Contract No. T201907404.01
Federal Aid Project No. NH-N059(46)
Rehabilitation of I-95, Bearing Replacements
New Castle County

Enclosed is Addendum No. 4 for the referenced contract consisting of the following:

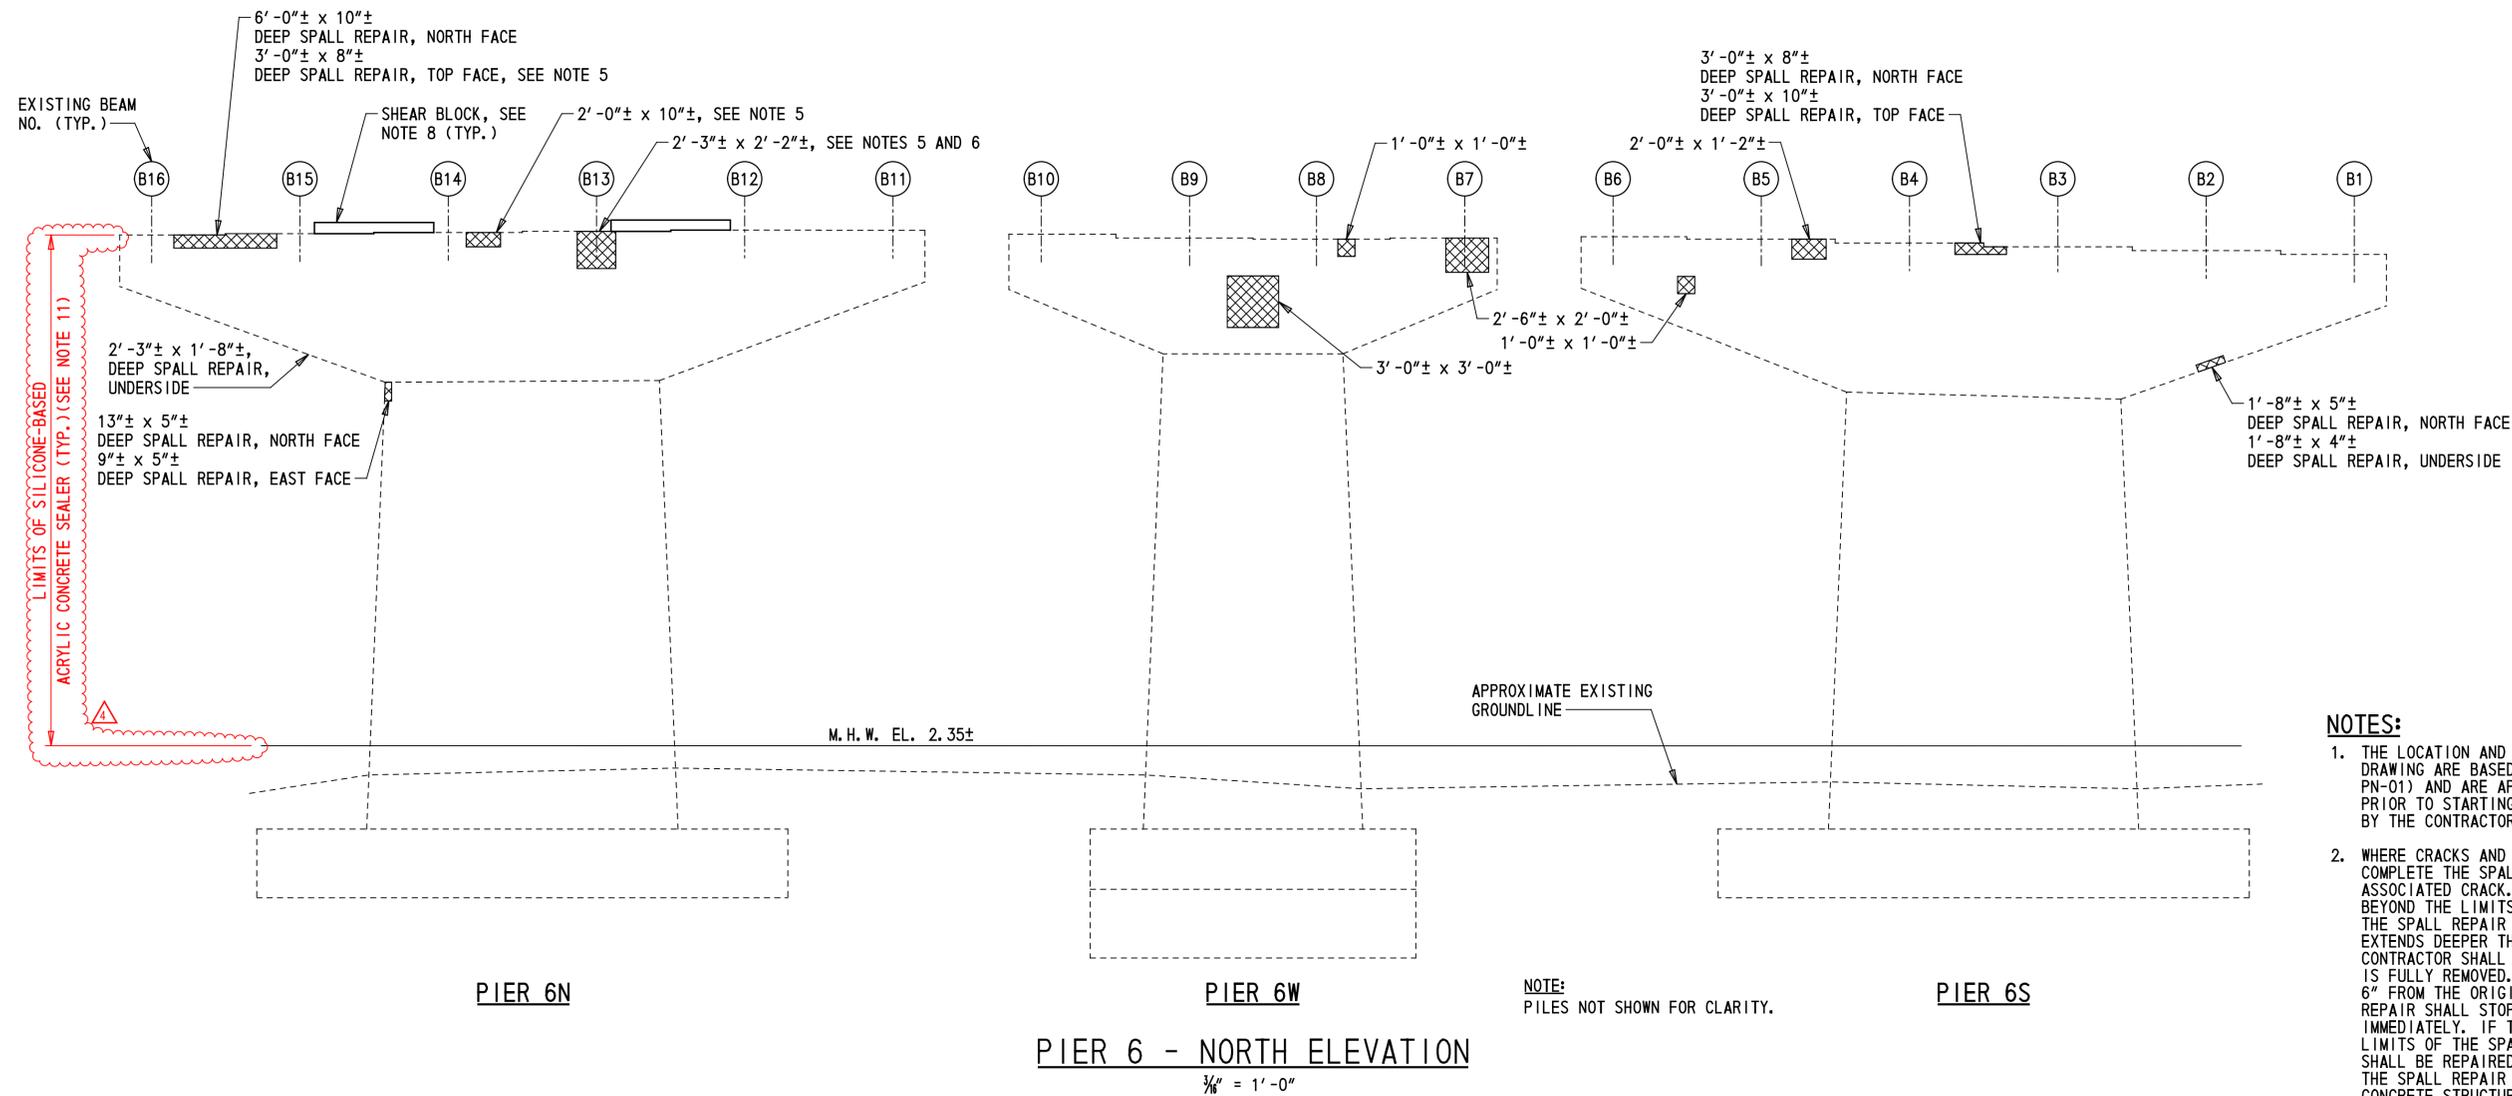
ADDENDA / REVISIONS
 △ ADDED SUBSTRUCTURE REPAIR NOTES - C. MALKIN 3/2/2020

- NOTES:**
1. THE LOCATION AND QUANTITIES OF THE REPAIRS SHOWN ON THIS DRAWING ARE BASED ON INSPECTION NOTES (SEE NOTE 9 ON DWG. PN-01) AND ARE APPROXIMATE AND REQUIRE FIELD VERIFICATION. PRIOR TO STARTING EACH REPAIR, THE LIMITS SHALL BE VERIFIED BY THE CONTRACTOR IN THE PRESENCE OF THE ENGINEER.

2. WHERE CRACKS AND SPALLS/DELAMINATIONS EXIST CONCURRENTLY, COMPLETE THE SPALL REPAIR COMPLETELY REMOVING THE ASSOCIATED CRACK. IF THE CRACK EXTENDS LESS THAN 1'-0" BEYOND THE LIMITS OF THE SPALL REPAIR, EXTEND THE LIMITS OF THE SPALL REPAIR TO ENCOMPASS THE CRACK. IF THE CRACK EXTENDS DEEPER THAN THE LIMITS OF CONCRETE REMOVAL, THE CONTRACTOR SHALL REMOVE ADDITIONAL CONCRETE UNTIL THE CRACK IS FULLY REMOVED. IF THE DEPTH OF REMOVAL REACHES MORE THAN 6" FROM THE ORIGINAL FACE OF CONCRETE, ALL WORK ON THE REPAIR SHALL STOP AND THE ENGINEER SHALL BE NOTIFIED IMMEDIATELY. IF THE CRACK EXTENDS MORE THAN 1'-0" BEYOND THE LIMITS OF THE SPALL REPAIR INTO SOUND CONCRETE THE CRACK SHALL BE REPAIRED BY EPOXY INJECTION BEYOND THE LIMITS OF THE SPALL REPAIR AND PAID FOR UNDER ITEM 628001 - REPAIR OF CONCRETE STRUCTURES BY EPOXY INJECTION. PAYMENT FOR CRACK REMOVAL LOCATED WITHIN SPALL REPAIRS WILL BE CONSIDERED INCIDENTAL TO ITEM 628041 - DEEP SPALL REPAIR.

8. FOR SHEAR BLOCK DETAILS, SEE DWG. PR-09.
 9. EPOXY CONCRETE SEALER SHALL BE APPLIED TO THE BEAM SEATS AND BEARING PEDESTALS. PAYMENT WILL BE MADE UNDER ITEM 613000 - EPOXY CONCRETE SEALER. CONTRACTOR SHALL REMOVE DEBRIS FROM THE BEAM SEAT PRIOR TO APPLICATION OF EPOXY CONCRETE SEALER. PAYMENT FOR THIS WORK WILL BE INCIDENTAL TO ITEM 613000 - EPOXY CONCRETE SEALER.

10. CONTRACTOR SHALL TAKE CARE TO PROTECT THE BEARINGS DURING APPLICATION OF THE EPOXY CONCRETE SEALER. ANY CLEAN-UP REQUIRED TO REMOVE THE SEALER FROM THE BEARINGS WILL BE AT NO ADDITIONAL COST TO THE DEPARTMENT AND TO THE SATISFACTION OF THE ENGINEER.
